HENDERSON COUNTY DEPARTMENT OF PUBLIC HEALTH  
 IMPROVEMENTS PERMIT  AUTHORIZATION TO CONSTRUCT   
 FOR INSTALLATION INSPECTION CALL 694-6043 BETWEEN 7AM-8AM

17080101978

Owner JEREMY ABEE Date 2-28-17  
 Property Address 117 DORNE DR.  
 Development \_\_\_\_\_ Lot No. \_\_\_\_\_  
 Location: KANUGA RD. TL DORNE DRIVE  
(JUST PAST BEAUMONT EST.'S) BEAR  
LEFT TO HOUSE AT END.  
 Residence  Mobile Home \_\_\_\_\_ Business \_\_\_\_\_  
 Other \_\_\_\_\_  
 Bedrooms 3  
 No. Employees 0 Design Flow GPD 360  
 Lot Size 1.60 AC  
 Basement: Yes  No  Basement Plumbing: Yes  No   
 Water Supply: City  Individual  Shared  Community   
 Other \_\_\_\_\_ WI# PE  
 Owner's Signature \_\_\_\_\_

\*\*VALID ONLY FOR USE AS DESCRIBED ABOVE—DRAWING NOT TO SCALE

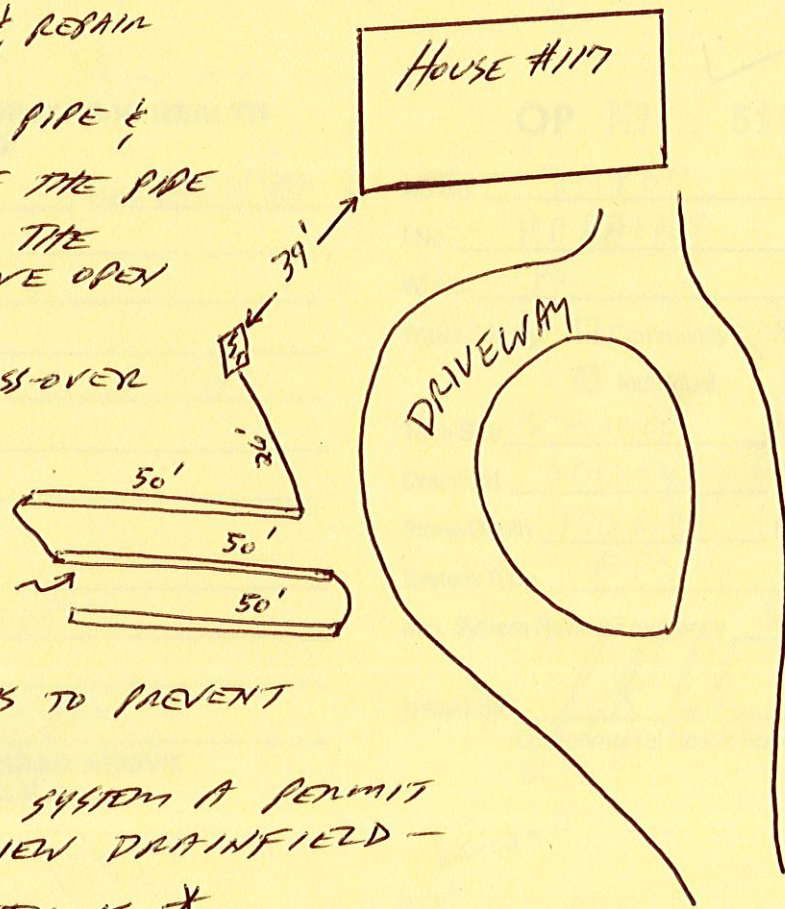
\* CLEAN WATER IS SURFACING ABOVE 2<sup>ND</sup> TRENCH.

- (1) INSPECT ALL FIXTURES FOR LEAKS & REPAIR IF NECESSARY.
- (2) UNCOVER EXIST CROSS-OVER PIPE & CONFIRM THAT THE BOTTOM OF THE PIPE IS EVEN WITH OR HIGHER THAN THE TOP OF EPS MATERIAL (LEAVE OPEN FOR INSPECTION).
- (3) PACK CLAY TIGHTLY AROUND CROSS-OVER PIPES AFTER INSPECTION.
- (4) REPLACE OUTLET TEE IN TANK ~~IF NEEDED.~~

- (5) WASH CLOTHES ON ALTERNATING DAYS TO PREVENT FLOODING DRAINFIELD.
  - (6) IF THIS DOES NOT REPAIR SYSTEM A PERMIT WILL BE ISSUED FOR A NEW DRAINFIELD -
- \* PLEASE CALL IF QUESTIONS \*
- \* SEE ATTACHED COPY OF 1999 REPAIR PERMIT \*
